**Stratham Planning Board  
AGENDA  
August 17, 2022  
Stratham Municipal Center  
Hutton Room  
Time: 7:00 PM**

- a. Tulip Tree, LLC (Owner), Kyle & Sophie Saltonstall (Applicants) - Request for approval of a site plan amendment to allow for modifications to the landscape plan associated with an event venue, non-profit lodge, and private school use at 61 Stratham Heights Road (Tax Map 5, Lot 81) approved by the Planning Board on March 6, 2019, Zoned Residential Agricultural.

**TO:** Planning Board Members  
**FROM:** Mark Connors, Town Planner  
**FOR:** July 13, 2022  
**RE:** **Site Plan Amendment application, 61 Stratham Heights Road**

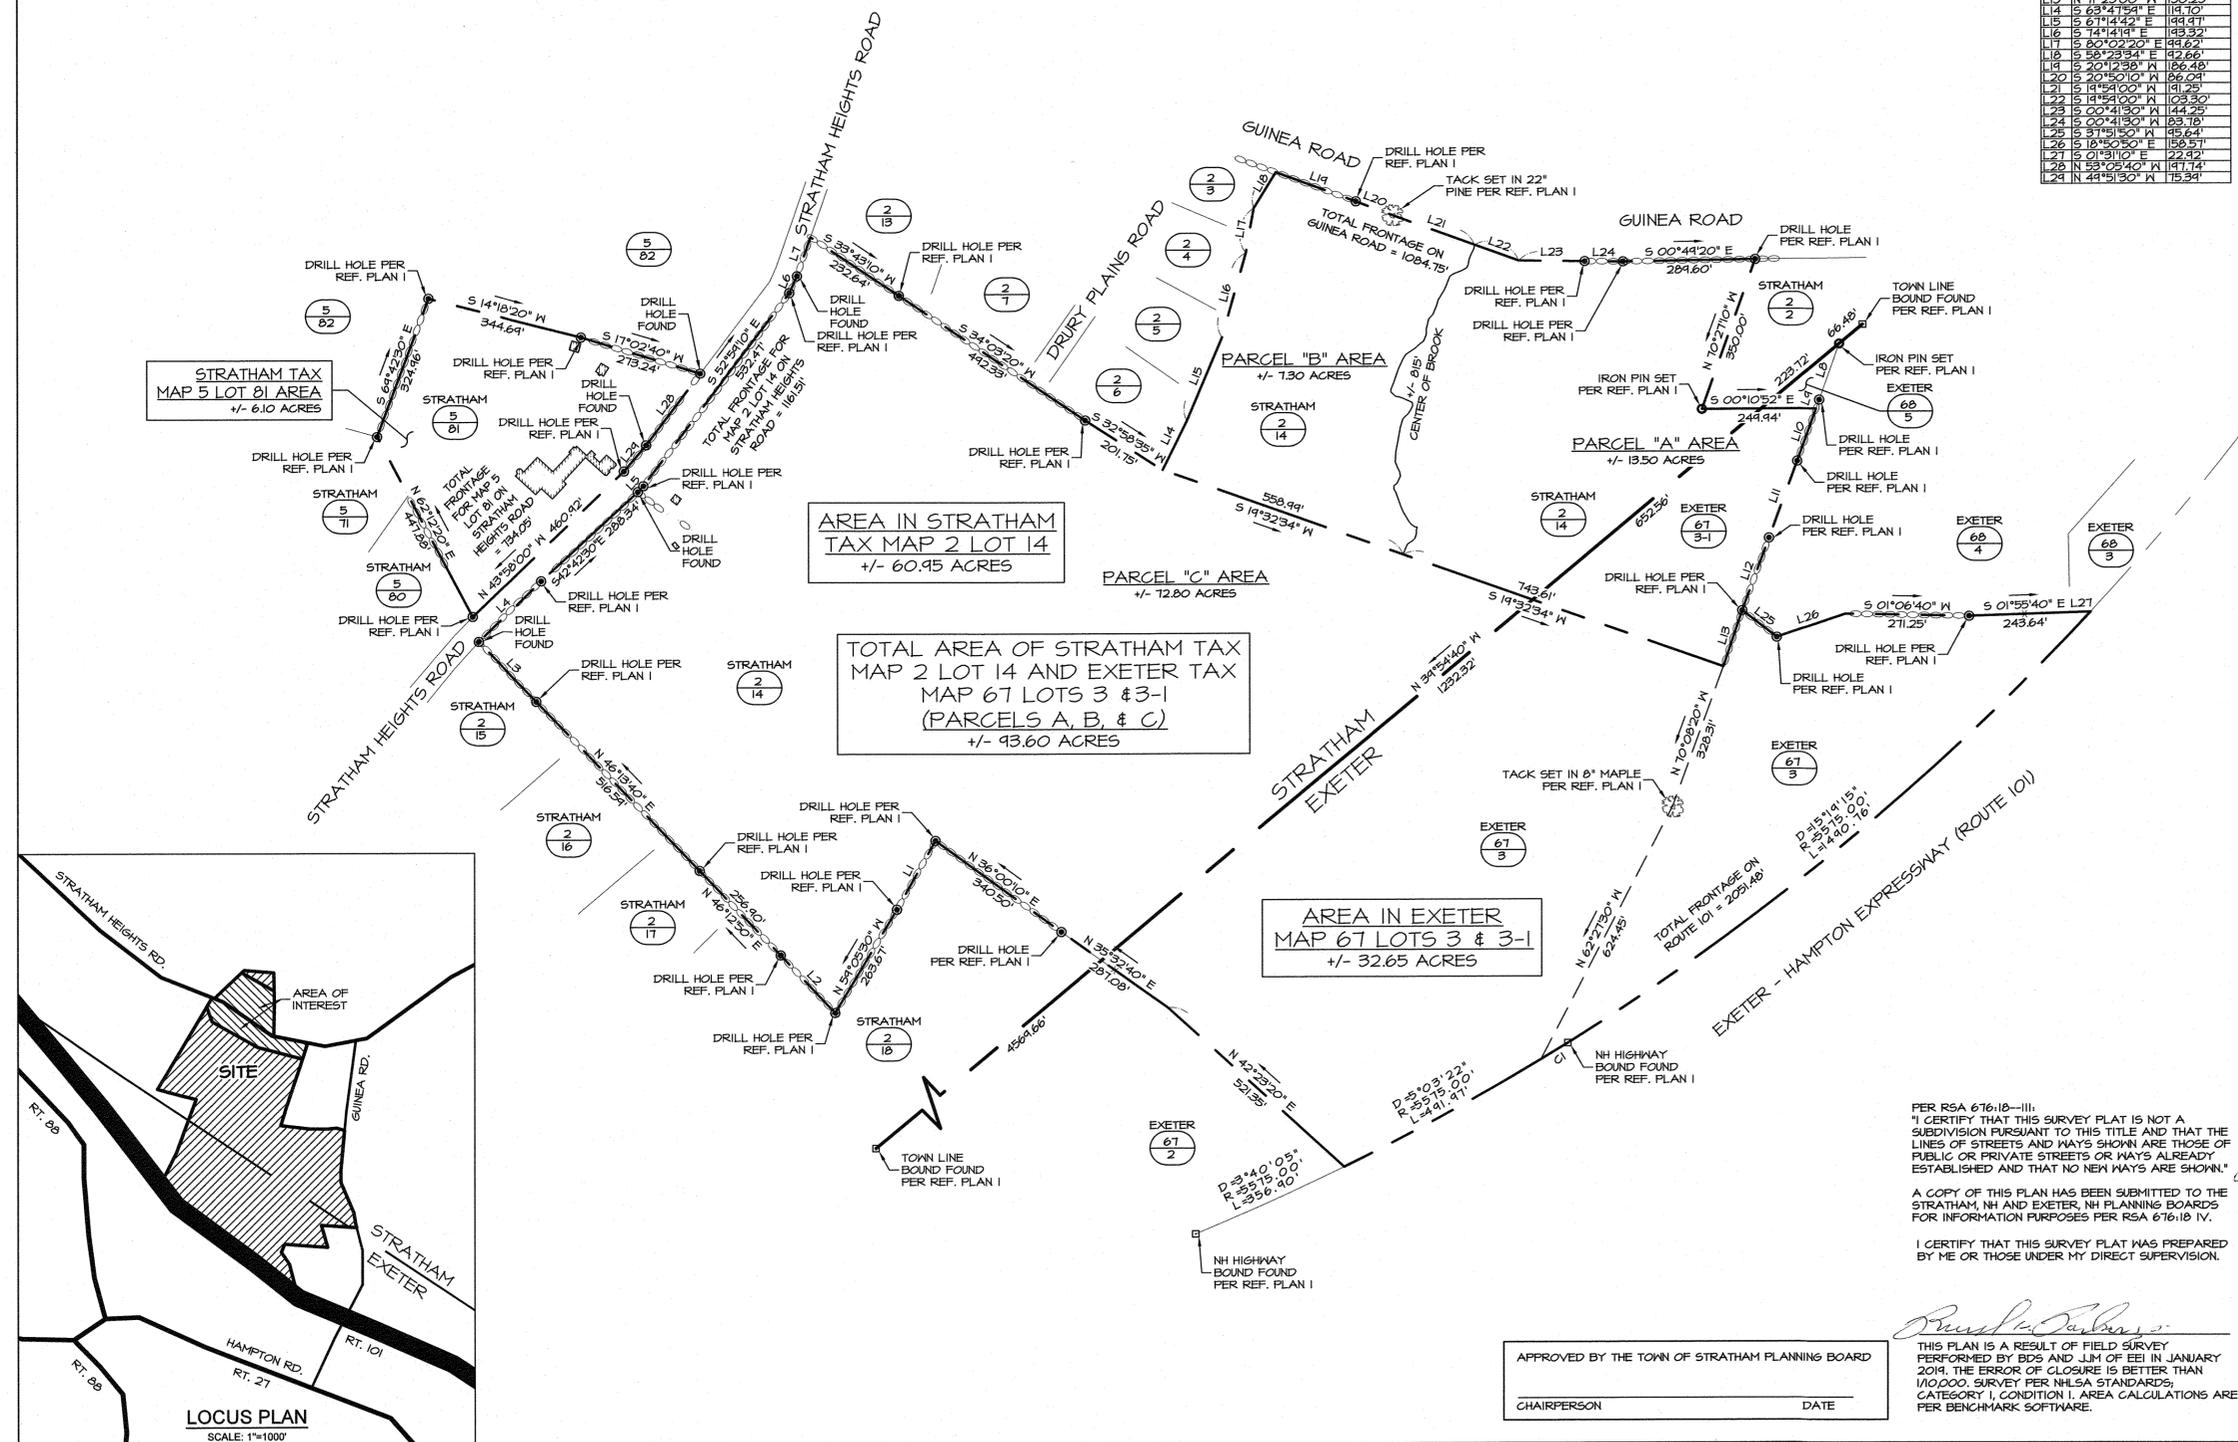
The site plan that the Planning Board approved included a row of 35 arborvitae trees adjacent to one of the parking areas. Although at one point the landscaping was installed, it appears many of the trees died and no longer exist.

The applicants are requesting that the landscaping in question be replaced, as a short-term measure, with eight rows of sweet corn that they have already planted. The Saltonstalls have not provided a plan or photographs of the corn so it is difficult to visualize what they are proposing, however staff will attempt to visit the site to take photos in advance of the Planning Board meeting. The applicants have indicated that they are working with engineers and landscape architects to develop a more comprehensive site management and landscape plan “that will far exceed the intent of the

Staff does not believe corn is a reasonable alternative to the more comprehensive landscaping that was included in the approved site plan. It is important to note that the Town did not develop the landscaping plan; the applicants developed the plan likely with some input from abutting property owners. The Town is merely enforcing the approved site plan the applicants developed. The Town would welcome the opportunity to review a revised landscape plan, but the applicants have not provided one, only the promise to submit one at a later unspecified date. It could be years before one is submitted. It has been nearly five months since the Town first formally notified the applicants of this compliance issue. Staff believes that should have provided sufficient time for the applicants to develop and provide the Town a revised plan.

Because the applicants have not provided a viable revised plan, staff would recommend that the Board deny the request for an amendment to the plan and uphold the original site plan but provide the applicants a 60-day window in which to make the improvements. However, staff would recommend that the Board provide the applicants some additional flexibility and allow for some minor revisions to the landscaping plan at the discretion of the Town Planner if a certified professional develops an alternative plan that meets the intent of the original landscape plan (see language of Condition #1).

I move that the Planning Board deny the request for a site plan amendment because the request is not in conformance with Section 5.2 of the Stratham Site Plan Regulations. Further, the Planning Board directs the Code Enforcement Officer to enforce the approved 2019 Site Plan for 61 Stratham Heights Road, but to withhold enforcement action for a period of 60 days to allow the applicants the opportunity to bring the property in compliance. This decision is subject to the following condition:

1.) The Town Planner may approve minor revisions to the approved landscape plan, at his discretion, if a certified professional provides written justification for the revisions and if the revised plan is consistent with the purpose and intent of the approved landscape plan.
